Planning Commission Meeting Meeting

Planning Commission Meeting Agenda Report

TO: Jodie Steffes, Community Development Director
FROM: Beth Richmond, City Planner
SUBJECT: South 47 Retail Site Plan
DATE: July 15, 2026
APPLICANT: Classic Construction (Brian Larson)
LOCATION: 4201 Saint Francis Blvd NW (PIN 06-33-24-11-0083)
COMP PLAN: Commercial
ZONING: B-2 General Business

1 SITE PLAN
A1 SCALE: 1" = 20'-0"

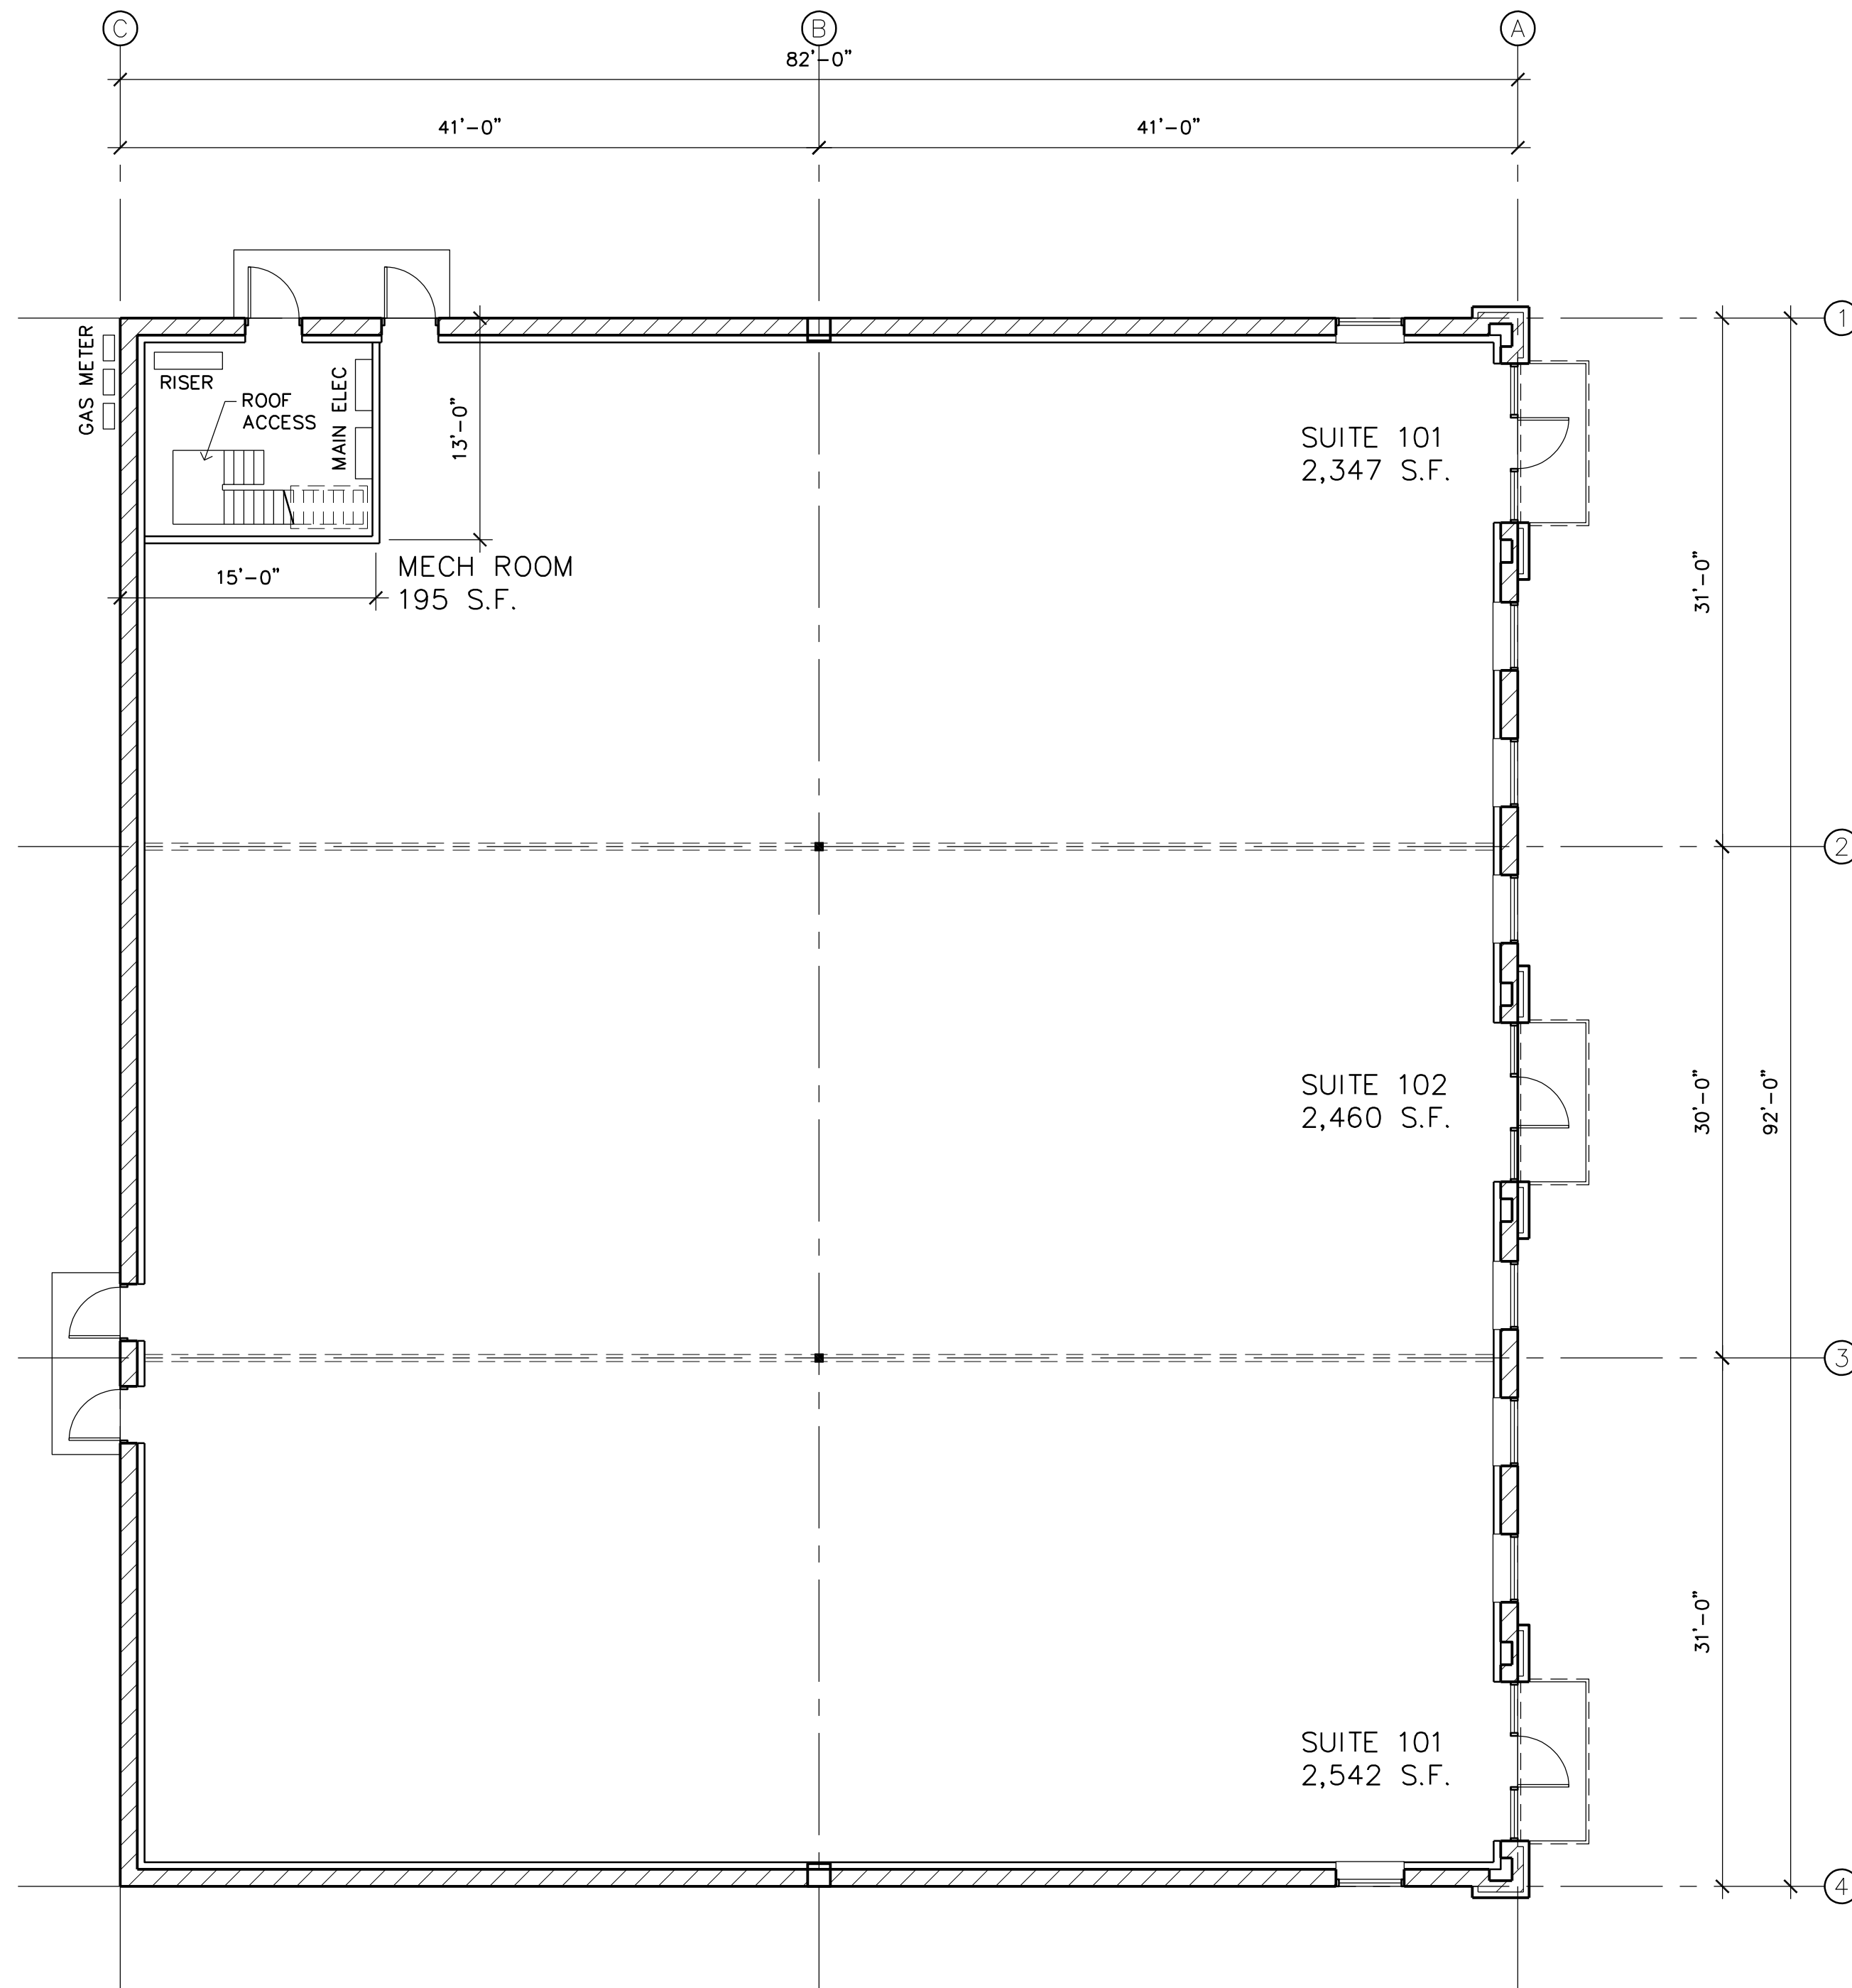
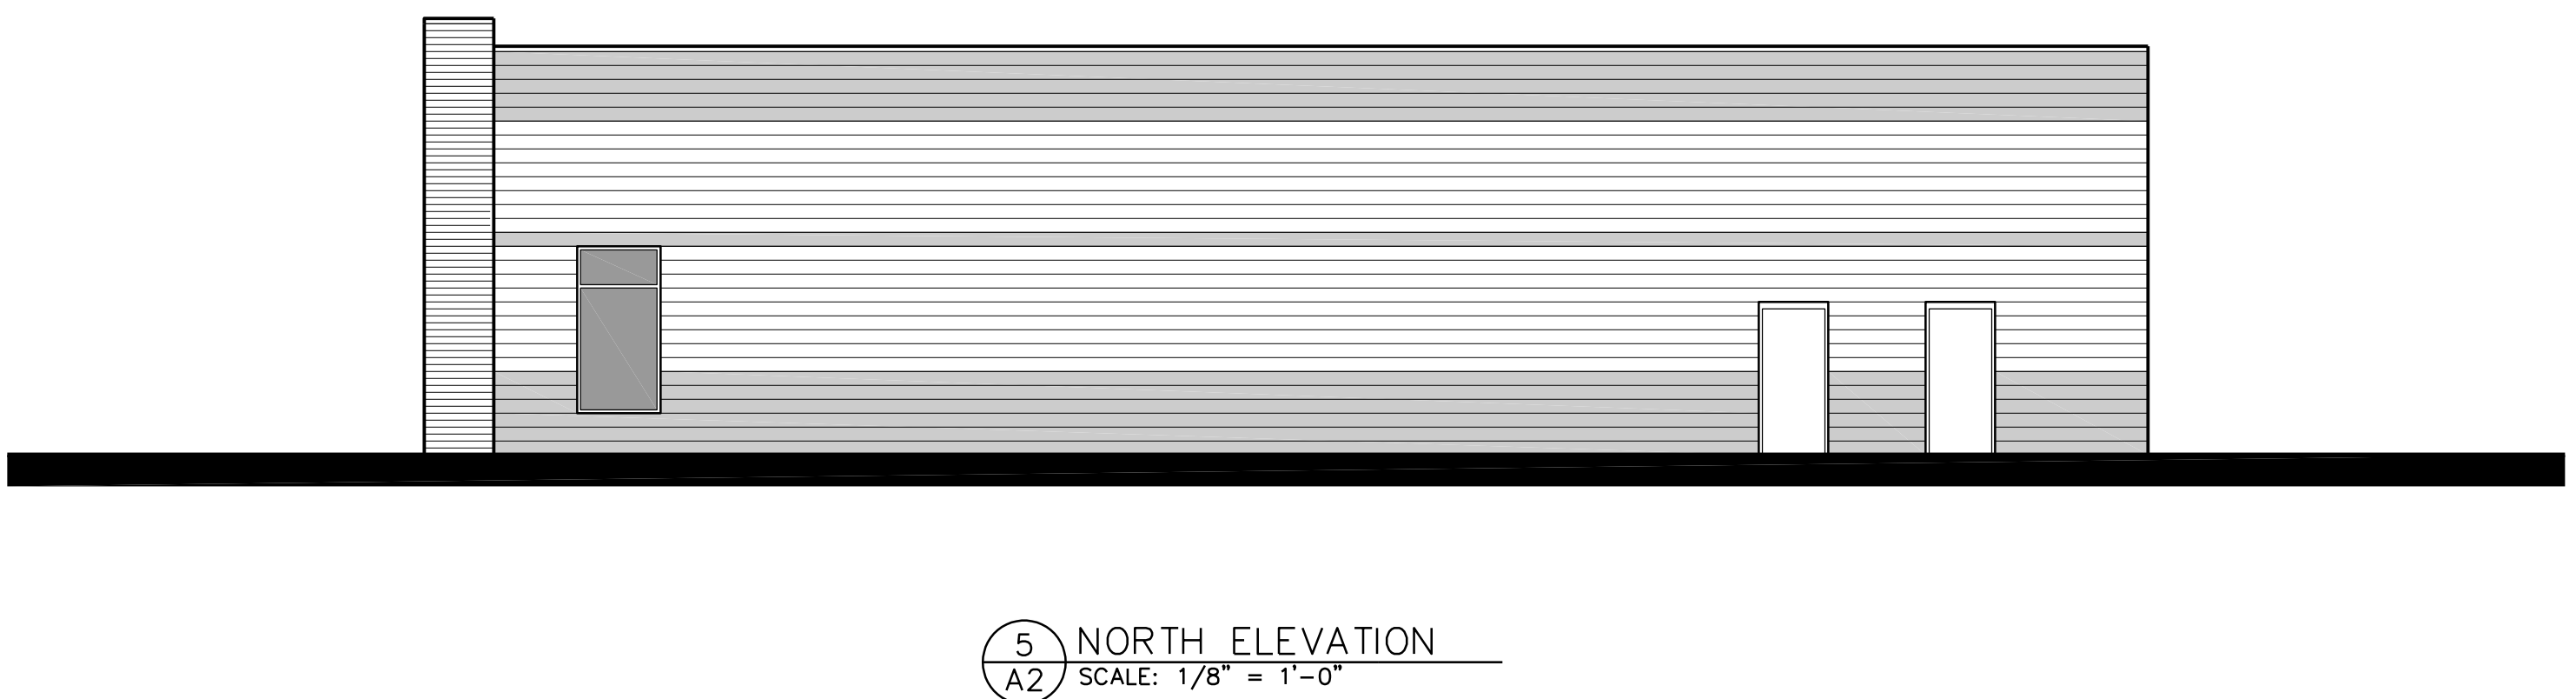
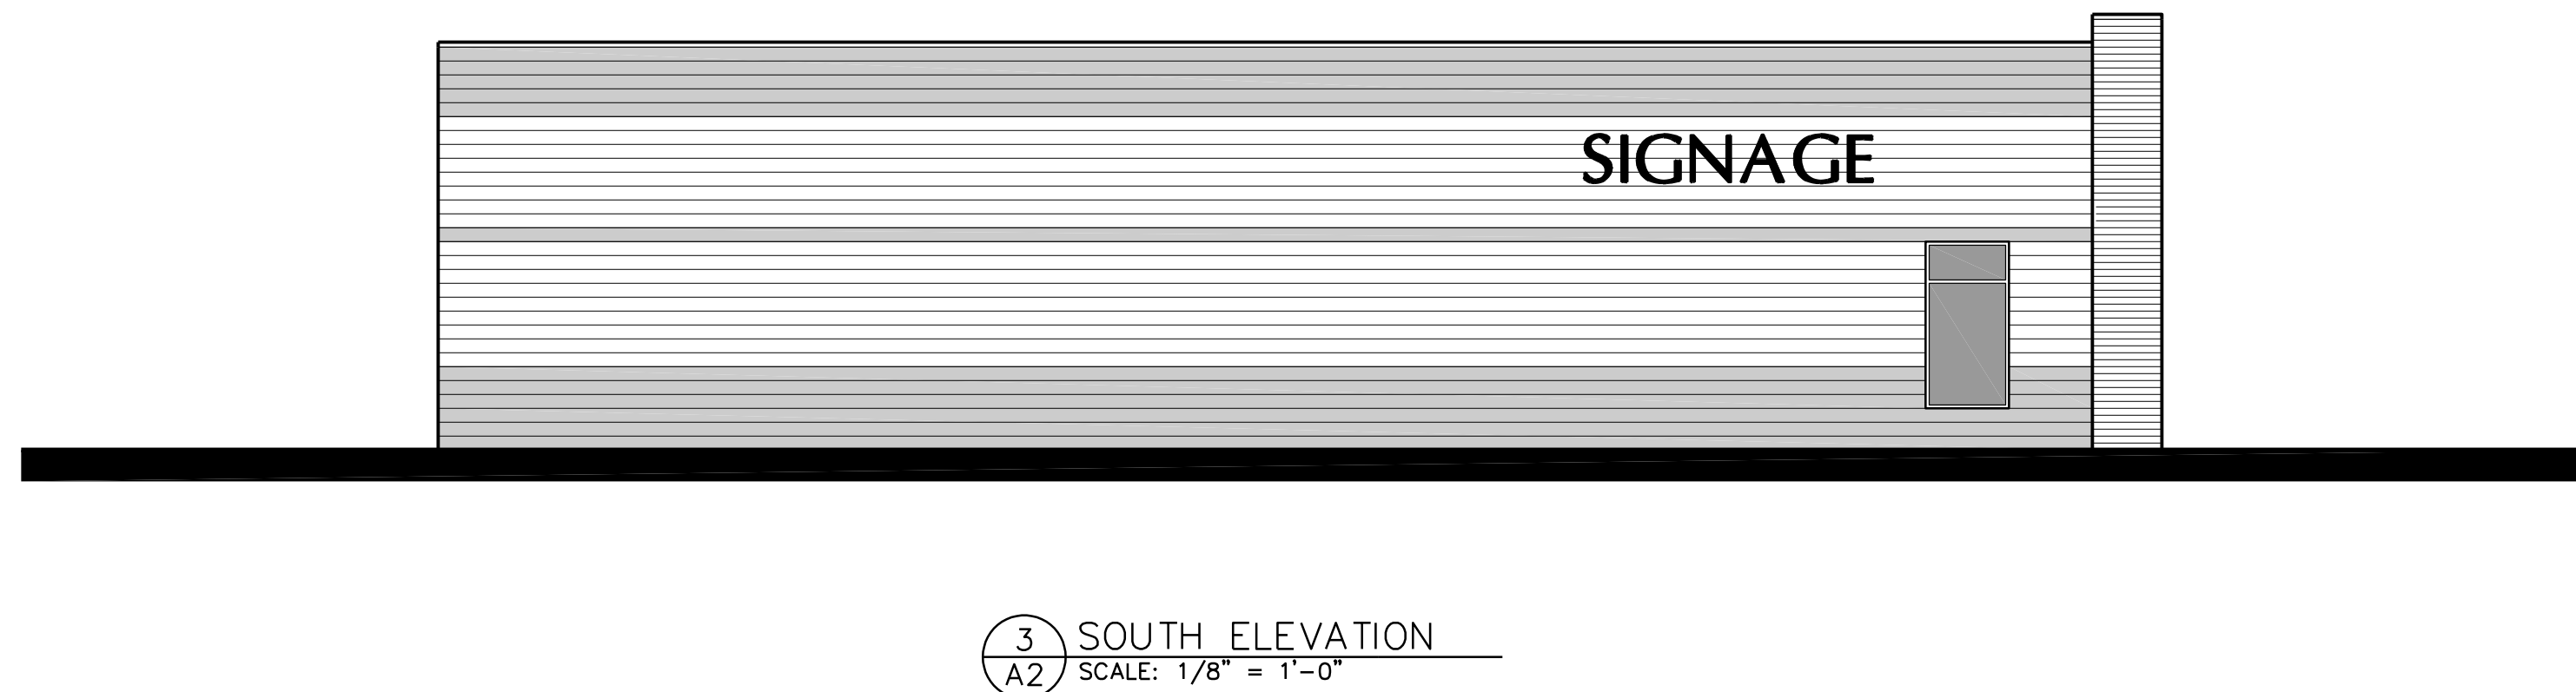
Staff has identified a discrepancy in the way that the setbacks have been labeled on the site plan. Based on the definitions below, the property lines should be labeled as follows:

Because of this discrepancy, the building has been proposed 18' from the west property line, which does not meet the rear setback requirement of 25'. The applicant will need to adjust the plans to meet the required setback.

City Code requires standalone retail parking to be provided at a rate of 1 space per 200 SF of floor area of retail space and 1 space per 500 SF of storage area. The applicant proposes a parking area with 29 stalls (28 provided and 1 proof of parking) located east of the building. The proposed parking area does not meet the minimum requirements for number of stalls, which calculates to 37 stalls. The applicant should update the plans to meet the minimum number of parking stalls.

1. The applicant shall revise the site plan to properly identify all setbacks and meet the minimum 25-foot rear setback requirement.
2. The front building wall (east side) shall be revised to ensure that 100% of the façade is made up of high-quality materials as listed in Code Section 10-71-08 Building Type and Construction, or the applicant must demonstrate that prefinished nichida

4. The applicant shall revise the site plan to meet the minimum number of parking spaces required by Code. Standalone retail parking must be provided at a rate of 1 space per 200 SF of floor area of retail space and 1 space per 500 SF of storage area, or 37 stalls.
